[AI2 MAX Soundbar STB]

Analysis Report(Audio noise issue when power on/off)

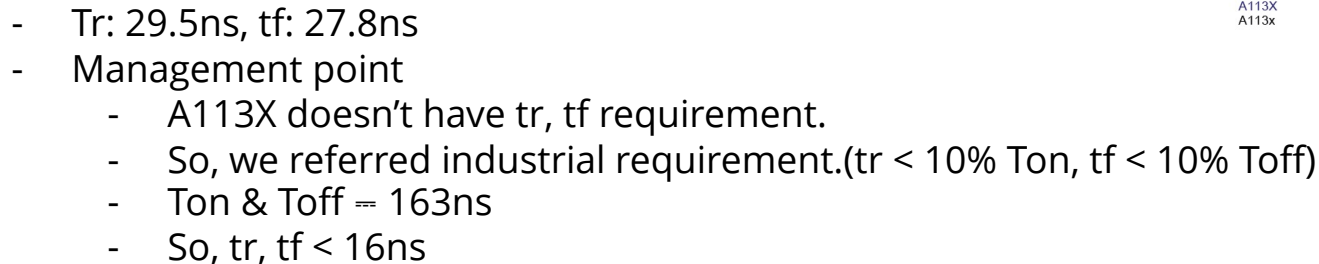
It is a log from testing start. So in front of the log is the OK cases, the last booting log is fail case. I see some abnormal message like below. I think this will cause audio noise.

Please help to check why the tdm capture is stop and capture repeatedly.

ECO point

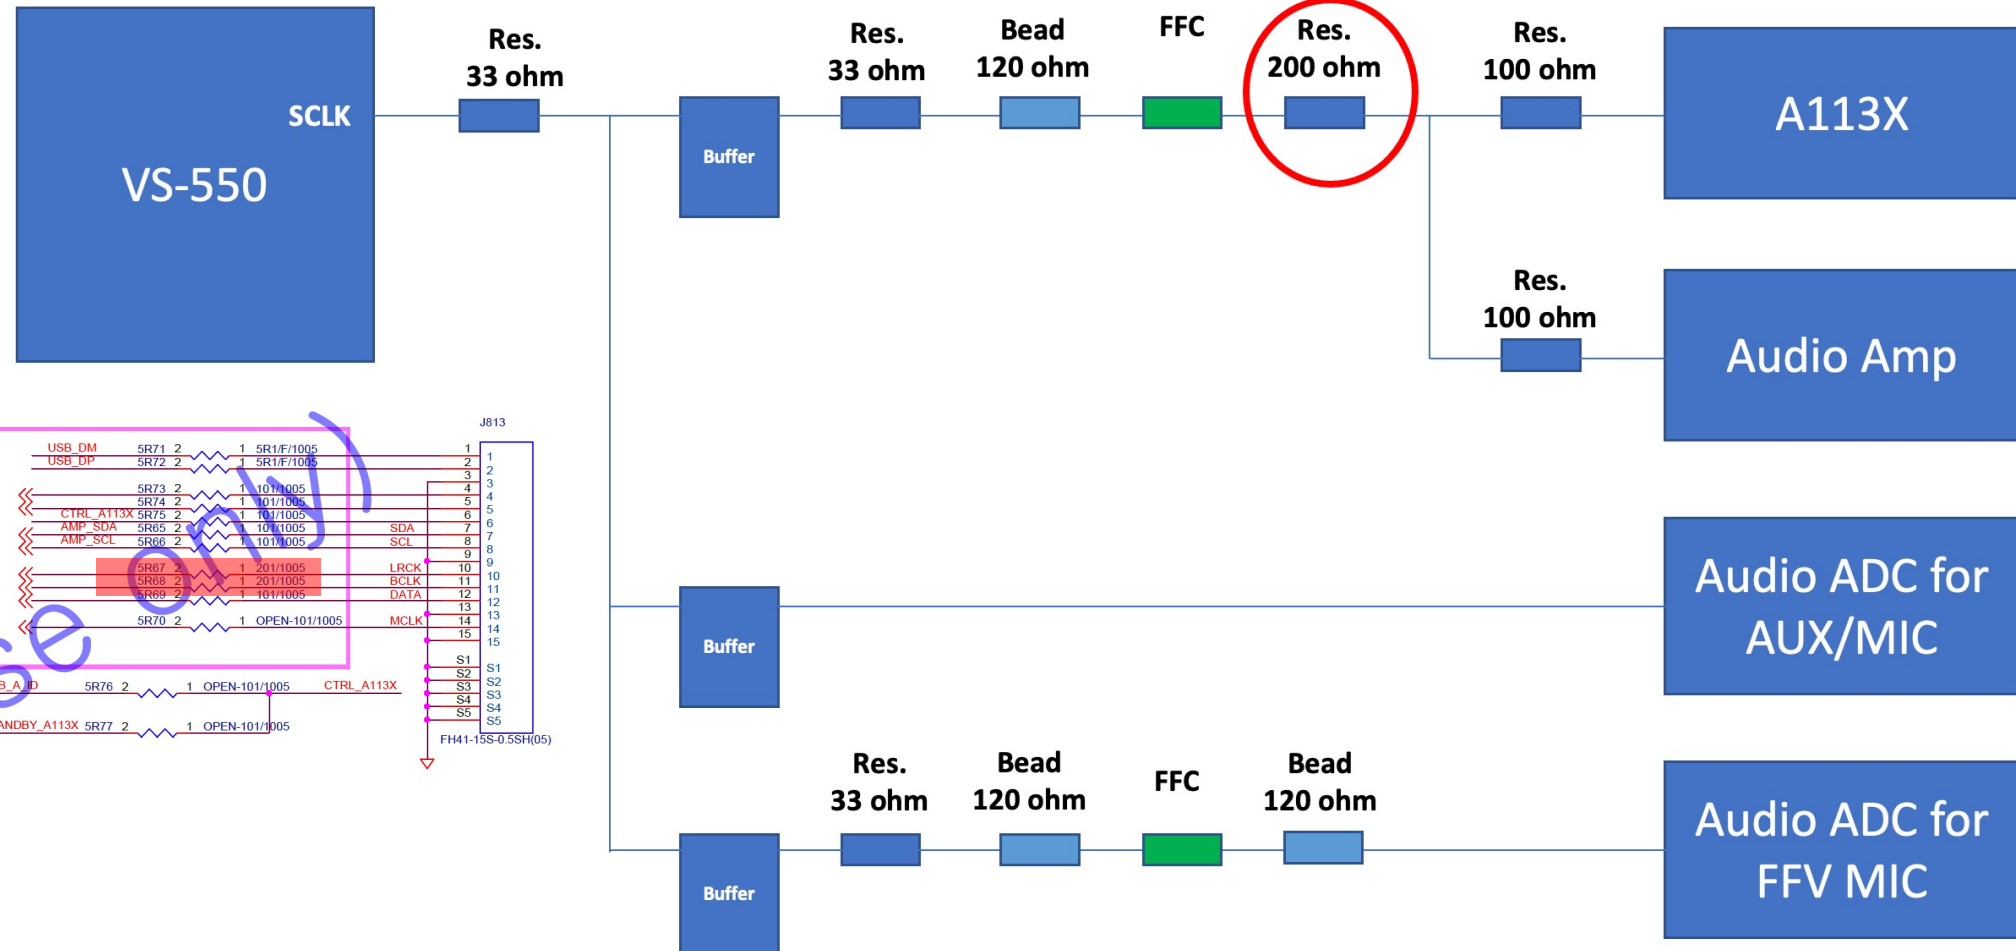
- Reproduce issue without any change(failure rate: 5/100)
- Waveform analysis
- A113X BCLK input(R107 pin1)

5R68, 5R67: 200ohm -> 51ohm

Analysis after ECO

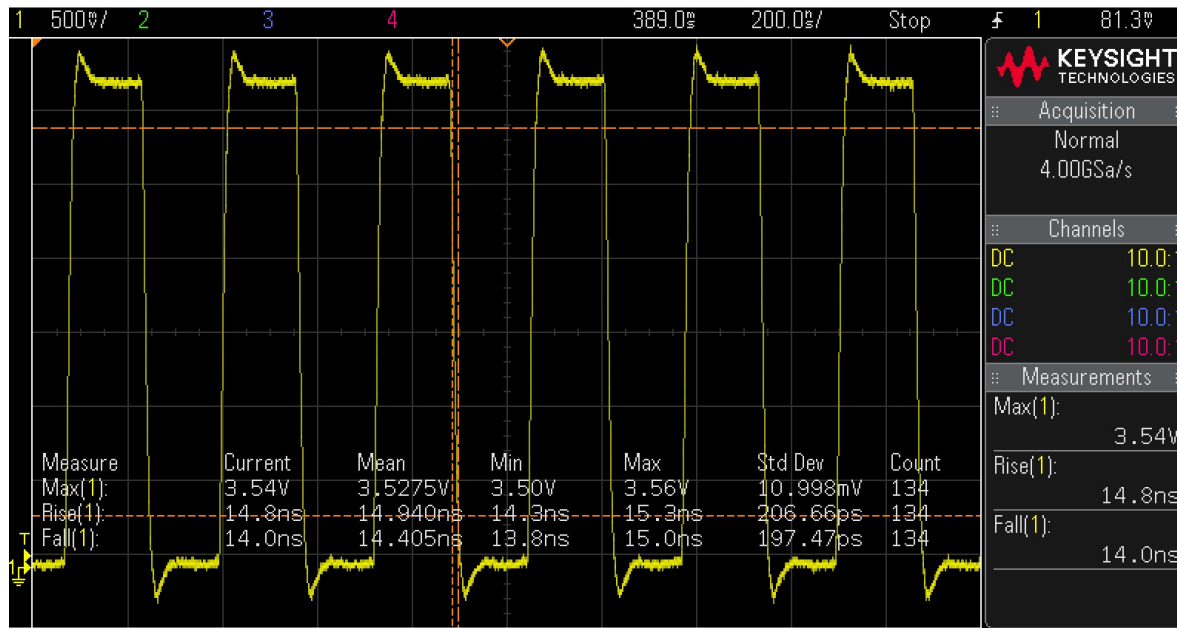
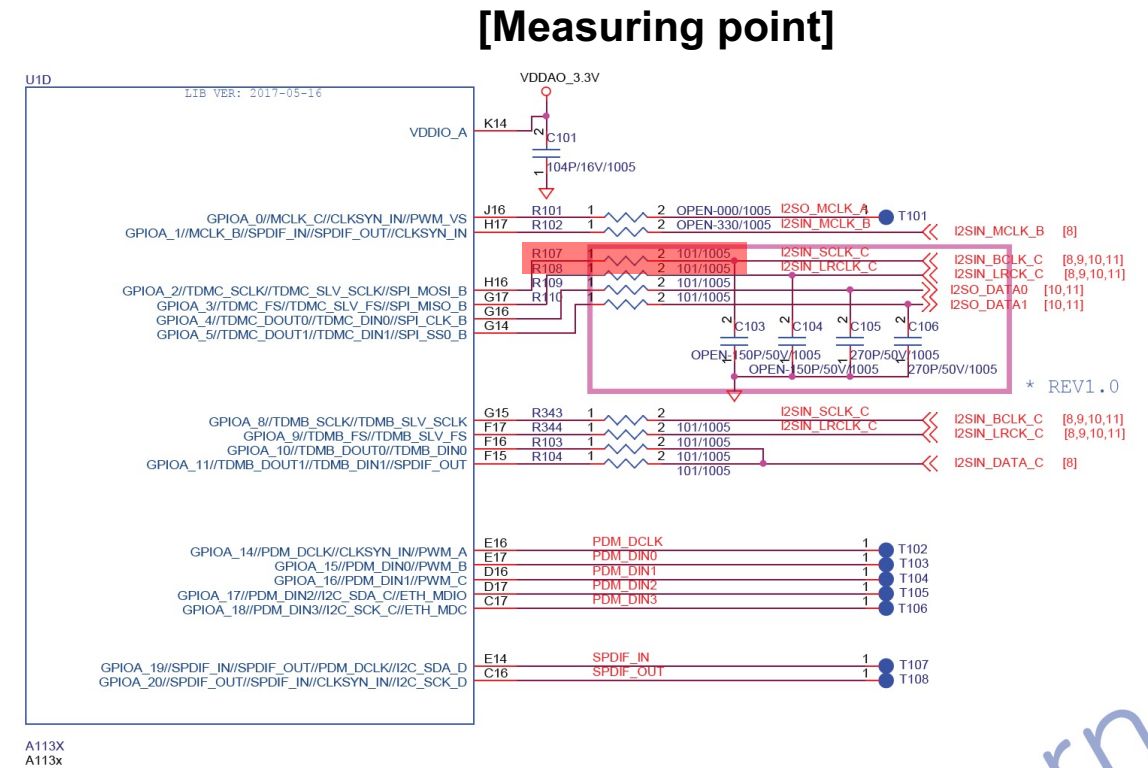
- Waveform analysis
- A113X BCLK input(R107 pin1)

- $T_r: 14.8ns < 16ns$
- $T_f: 14.0ns < 16ns$
- Test result: 0/100(failure rate)

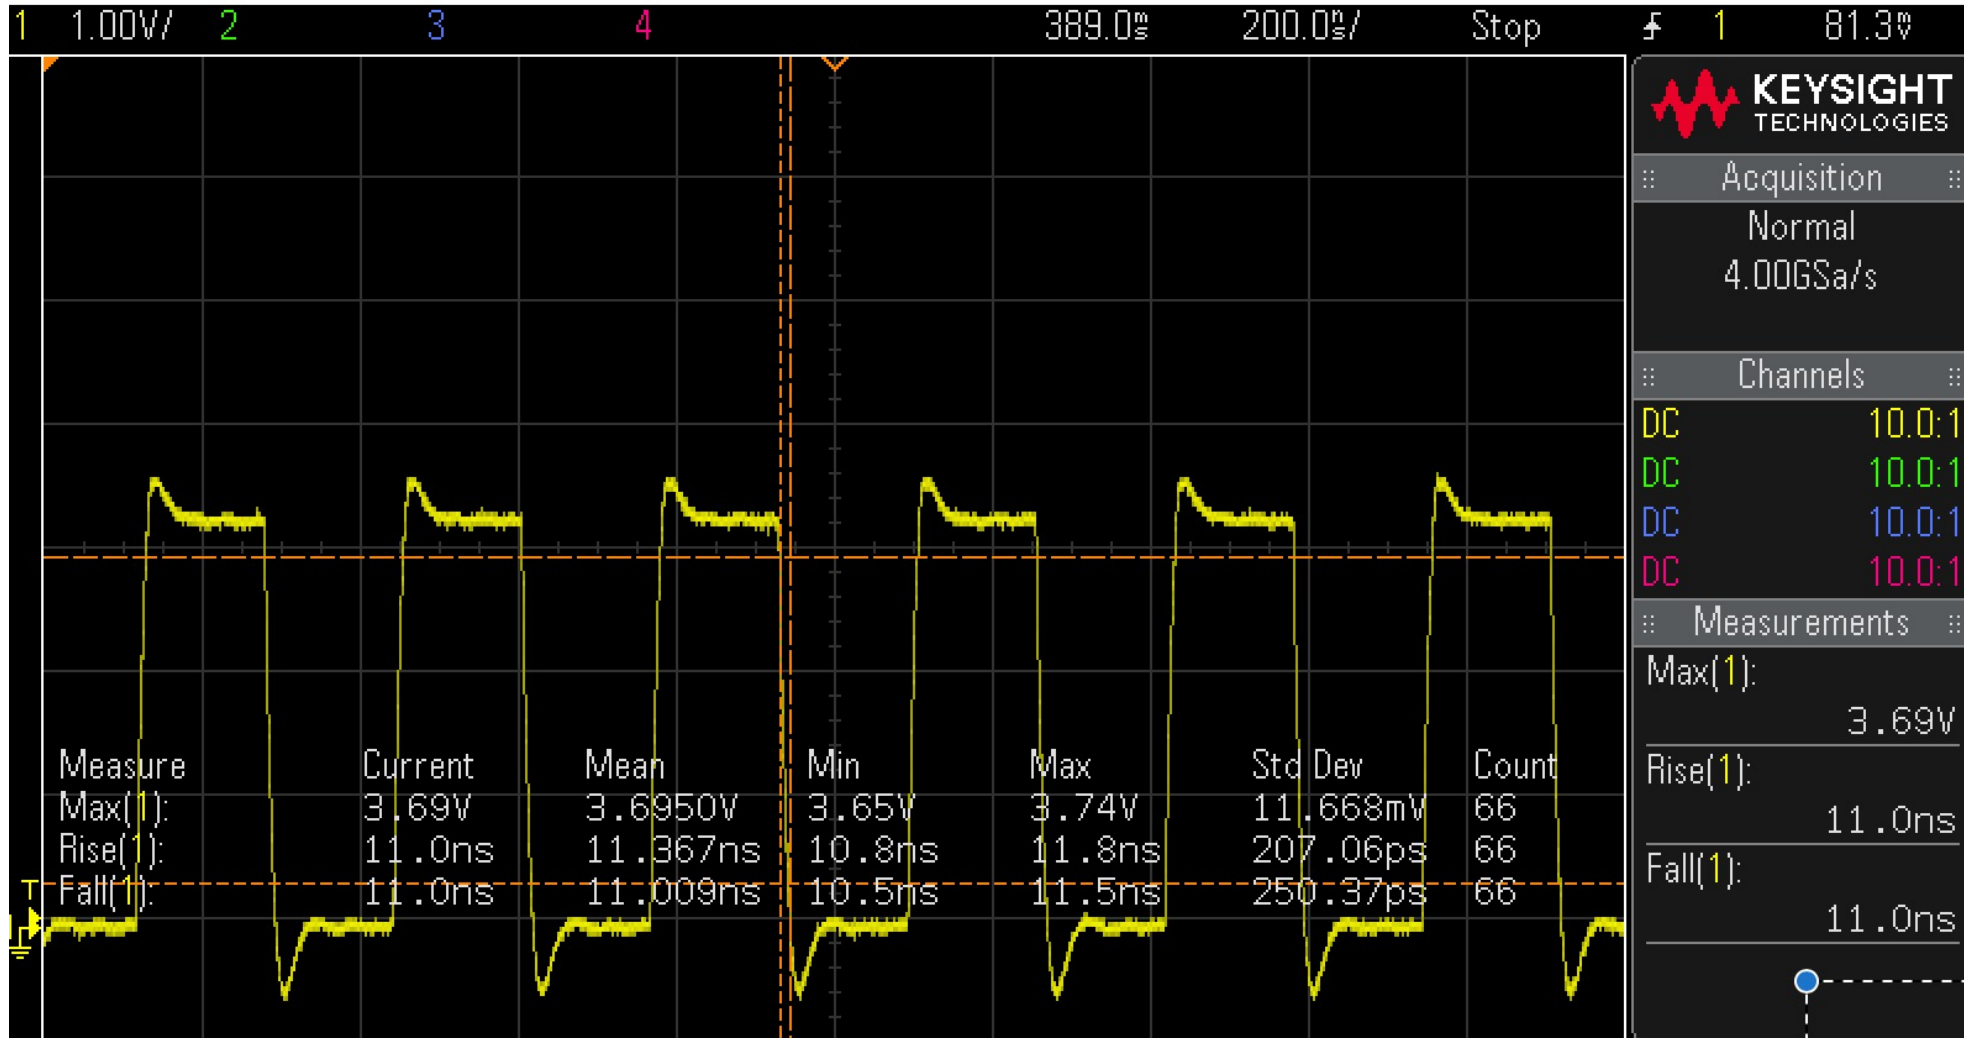
I2S waveform over CX20810 absolute maximum value

BCLK of I2S in CX20810(FFV ADC)

- Vmax: 3.69V(observed undershoot/overshoot)

I2S waveform exceed CX20810 absolute value

I2S shall not over 3.6V(absolute maximum rating)
-> So, Foxconn shall find suitable value it can not over absolute maximum rating.
